LAKE MANITOBA AND LAKE ST. MARTIN OUTLET CHANNELS PROJECT
RESPONSE TO IAAC TECHNICAL INFORMATION REQUESTS

Question IAAC-22

QUESTION IAAC-22

Location of the LSMOC and Existing Drainage Patterns

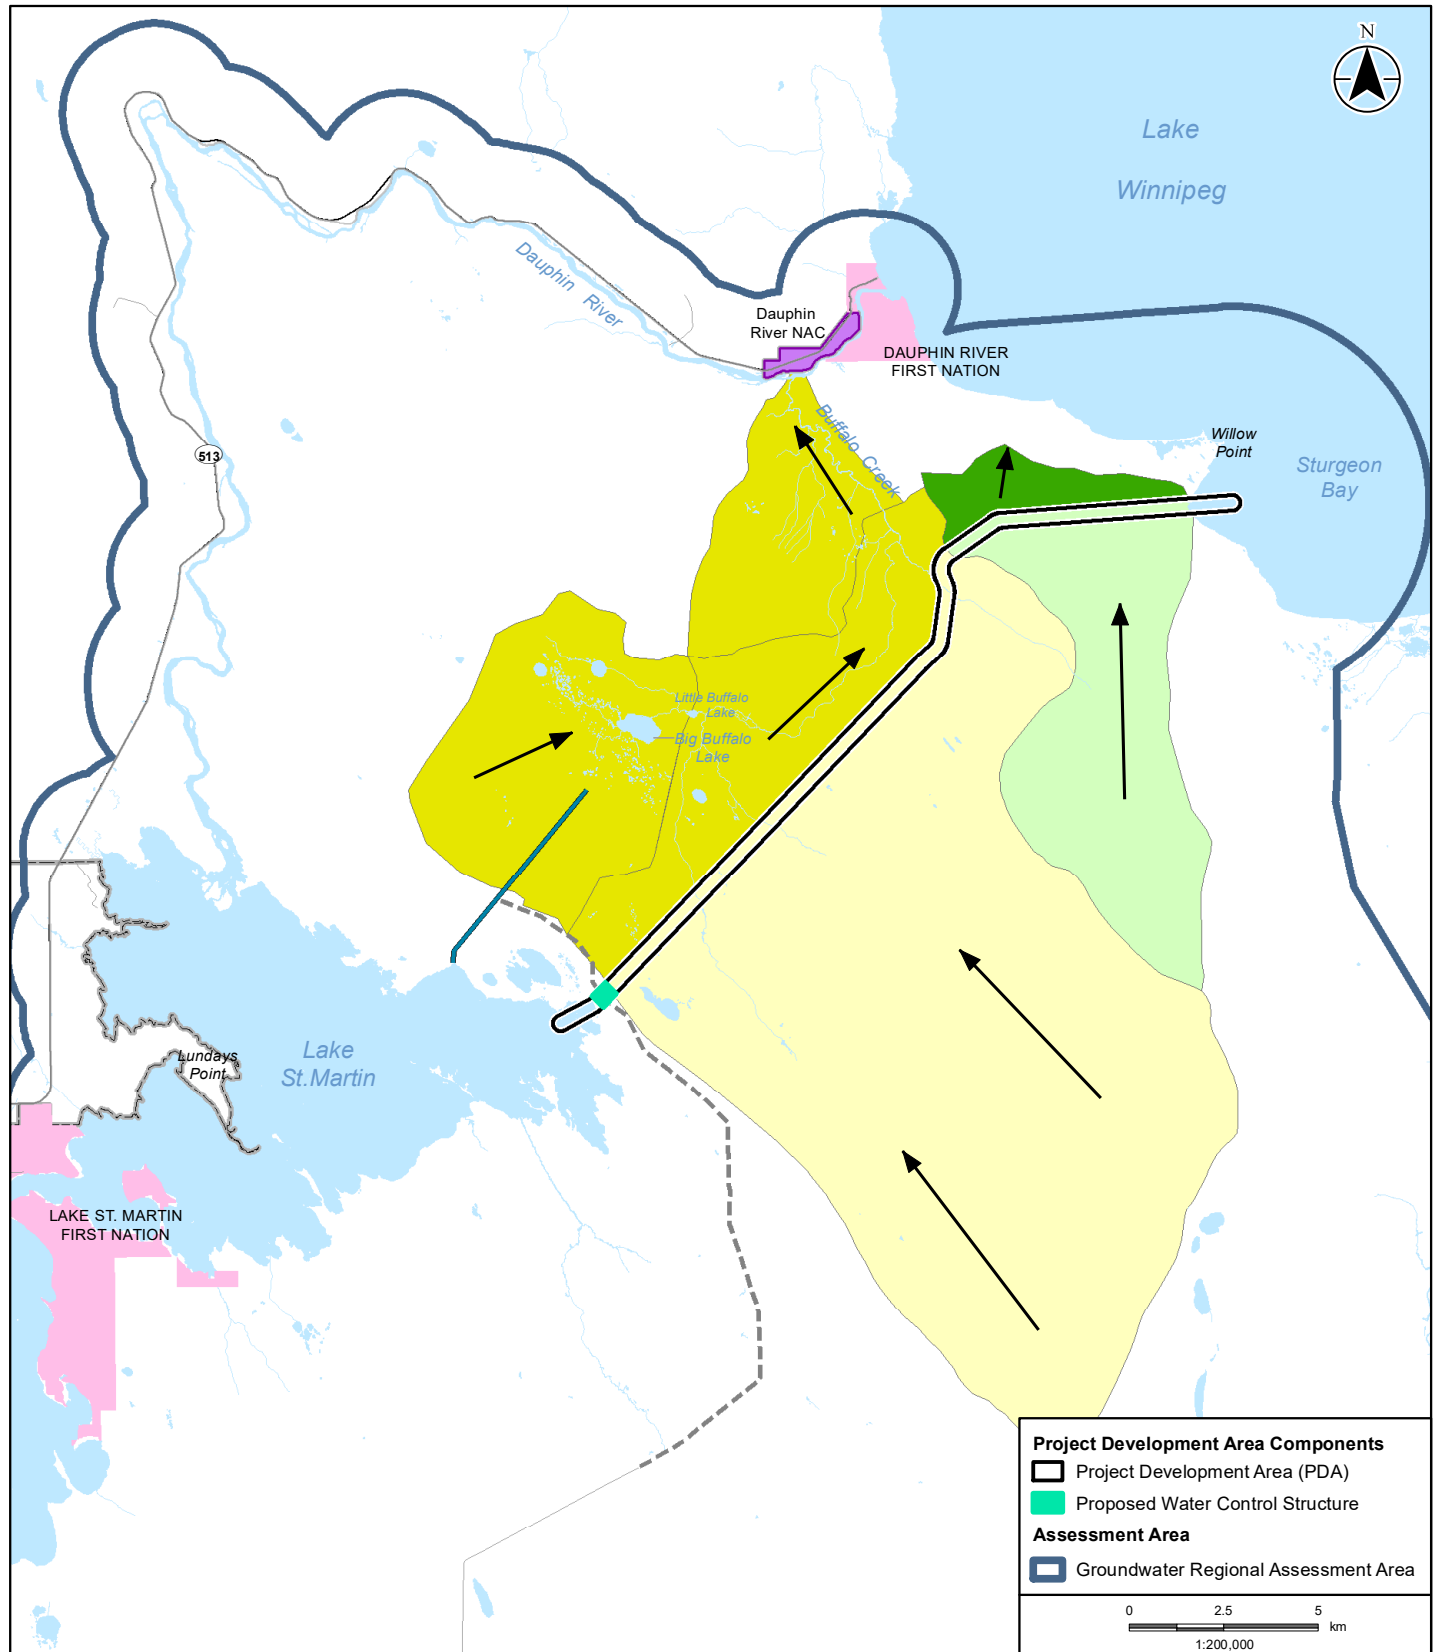
The EIS identifies different areas for the RAA for the soils, groundwater/geology, and surface water VCs. It is not clear how the Buffalo Lake watershed overlaps with the selected RAAs. In the EIS, the proponent refers to Appendix 6B, Figure 6.4B-8 to describe the Buffalo Lake watershed. However, this figure does not define the Buffalo Lake watershed boundaries. The EIS notes that defining the watershed boundary of a wetland is difficult and generally describes the Buffalo Creek watershed as consisting of Big Buffalo Lake, Little Buffalo Lake, Buffalo Creek and several small unnamed lakes, ponds and creeks as having a very complex hydrology. Understanding the rationale for the selected RAA is necessary to support the assessment of changes from the Project to water and associated effects, including effects to fish and fish habitat.

- a) Discuss applicability of the RAA for surface water and given Buffalo Lake watershed boundaries. If warranted, presented revised figures to demonstrate consideration of the Buffalo Lake watershed boundaries in the selection of the RAA for surface water.
 - i. Provide baseline data of the Buffalo Lake watershed including but not limited to drainage areas, flow paths, and seepage of groundwater into surface water (and erosion and sedimentation) to inform understanding of the watershed boundaries and to support understanding of changes in flows. Present an updated figure to define the likely Buffalo Lake watershed boundaries.
 - ii. Provide field assessment data of the surface and shallow subsurface drainage flow in the LSMOC LAA considering the Buffalo Lake watershed.

- a) Big Buffalo Lake and Little Buffalo Lakes are also commonly referred to as Buffalo Lakes and are drained by Buffalo Creek; thus, are all part of the Buffalo Creek watershed. The drainage patterns and watershed boundaries are provided in the environmental impact statement (EIS) in Volume 2, Figure 6.4B-10 "Location of the LSMOC and Existing Drainage Patterns". The regional assessment area (RAA) encompasses the interpreted extent of the Buffalo Creek watershed.
 - i. Based on a topographical interpretation of a digital elevation model of the region the extent of the Buffalo Creek watershed (the groundwater RAA) is provided in Map 22-1, attached.
